IMPORTANT SAFETY RECALL
NHTSA Number: 24V-365 (School Bus)

SUBJECT: R24DA: FMVSS 301 Noncompliance - EV Fuel Fired Heater – Fuel Leak

R24DA: EV Fuel Fired Heater – Fuel Leak (FMVSS 301)

Figure 1

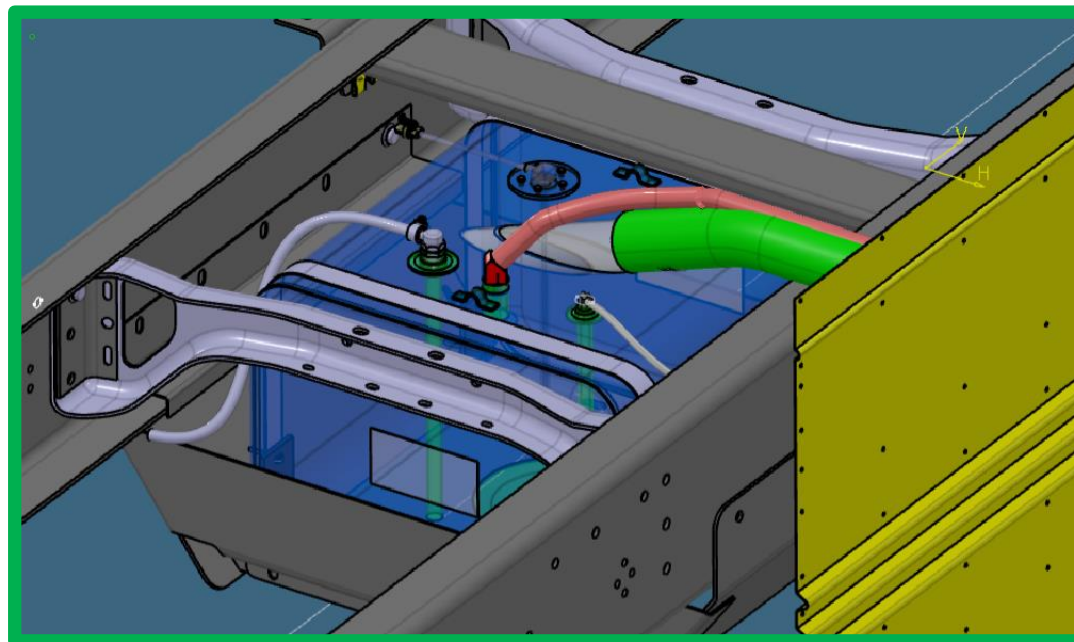
Issue: On identified buses there is a potential for diesel fuel to seep out of the 25-gallon auxiliary diesel fuel tank vent and onto the ground. The vent valve is designed to be installed into the vapor space of the tank. On some models, there is a standpipe below the vent valve. This stand pipe needs to be removed in order for the system to function properly.

Corrective Action: Ensure the aux fuel tank plumbing configuration is per Figure 1 below. If not, re-configure connections. Remove tank vent fitting from the tank, modify, and re-install.

Step 1: Inspect fuel tank interface connection points. Replace/relocate components, as required.

- Location A- Fuel Tank Vent
- Location B- Fill Neck Vent
- Location C- Fuel Fired Heater Supply

Step 2: Clean the area of dust/debris. Remove the vent line and vent valve and place aside

Step 3: Remove the threaded bung at location A out of the tank. It will have a stand pipe attached to the bottom

NOTE: You will need to bend the stand pipe as you remove the fitting from the tank. Bend as little as required to fully remove the bung/fitting assembly

Step 3: Cut the stand pipe off the bottom of the fitting

Step 4: Clean the threads on the fitting, apply Loc-tite™ 567 or equivalent, and install into the tank

Step 5: Re-Install the vent valve and associated plumbing
